UNITED STATES
NUCLEAR REGULATORY COMMISSION
OFFICE OF INSPECTION AND ENFORCEMENT
WASHINGTON, D.C. 20555

IE Bulletin No. 79-09

FAILURES OF GE TYPE AK-2 CIRCUIT BREAKER IN SAFETY RELATED SYSTEMS

EXTRACT OF GE SERVICE ADVICE LETTER
NO. 175(CPDD)9.3

FIGURE 1

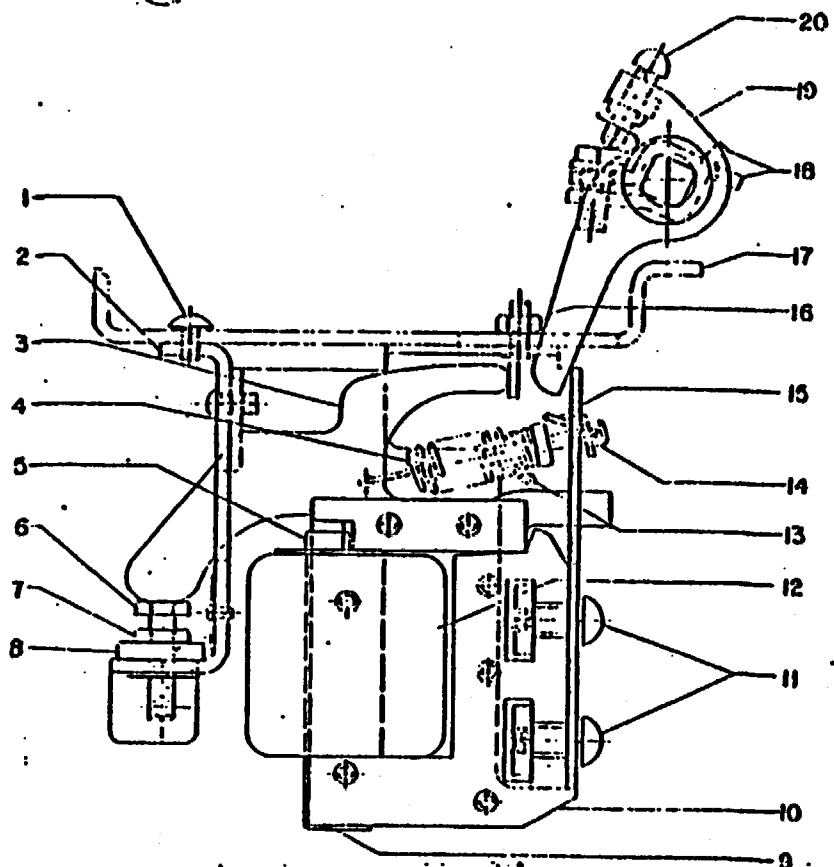
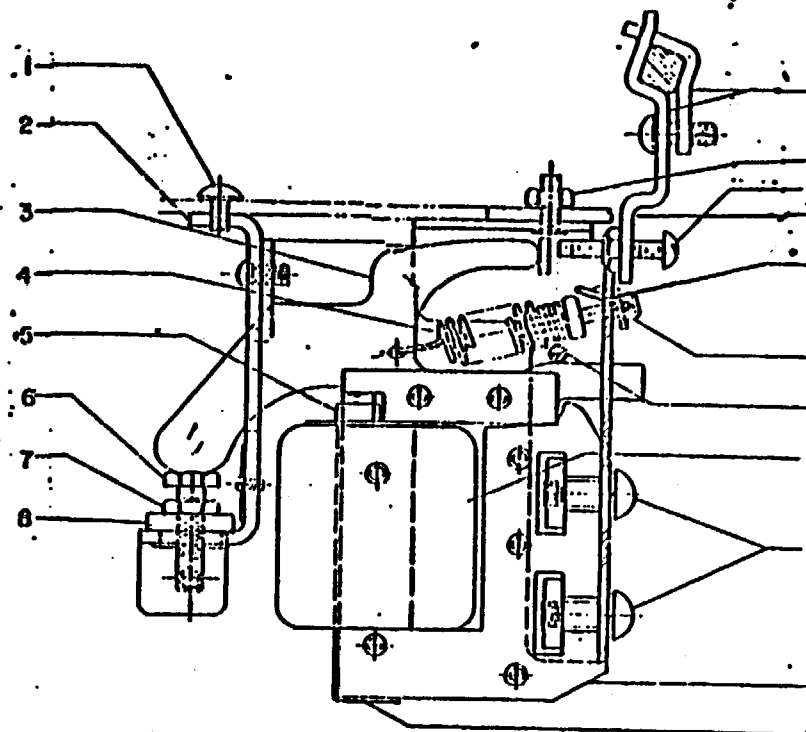
1. Check the undervoltage trip device to assure there is not excessive clearance between the armature and the rivet and that there are no binds as the armature moves through its travel when manually operated. If excessive clearance or binding exists, it should be adjusted by loosening screws (11) and moving the magnet (10) up or down as necessary to obtain the proper freedom of the armature (3) with respect to its pivot on magnet (10) and the guide provided by pivot (13).

2. Check (and adjust if necessary) the trip latch engagement. This adjustment is described in the maintenance manual for that particular breaker.
3. Check (and adjust if necessary) the pick-up setting of the instantaneous undervoltage device. In some instances, the standards for nominal voltage ratings and pick-up settings have been raised since the breakers were shipped from the factory. The new nominal voltages and pick-up settings deviate substantially from these values, the device should be readjusted while it is on the breaker.

To adjust the pick-up of the instantaneous undervoltage trip device, remove the Locking Wire (15) and turn the adjusting screw (14) clockwise to raise the pick-up to the desired setting. A suitable voltmeter and adjustable voltage source should be connected to the undervoltage device coil leads at the terminal board for stationary breakers or the secondary disconnects for drawout type breakers. On AC devices, the pick-up voltage should be read immediately before the armature closes its air gap. After the pick-up is adjusted, locking wire (15) should be installed.

- 4.. The torque required on the trip shaft to trip a closed breaker should not exceed 1.5 pounds-inches. This may be checked with the equivalent of an open-end wrench fabricated from a piece of sheet metal to which a spring scale can be fastened approximately 1 inch from the trip shaft centerline. Where the torque required to trip the breaker exceeds 1.5 pound-inches, hardened grease in the trip shaft bearings and/or latch bearing may be suspected or dirt may have accumulated on the trip latch surface. Hardened grease must be replaced or revitalized with a suitable solvent such as WD-40 or CRC 5-56 or the bearings must be replaced. Excessive grease and dirt should be removed from the trip latch surface.

5. The adjustment between the undervoltage trip device and the trip paddle on the trip shaft should be checked to assure the required positive trip is maintained (positive trip exists when approximately 1/32 inch additional travel of the armature occurs after the undervoltage device trips the breaker.) This adjustment is made with adjusting screw (20).
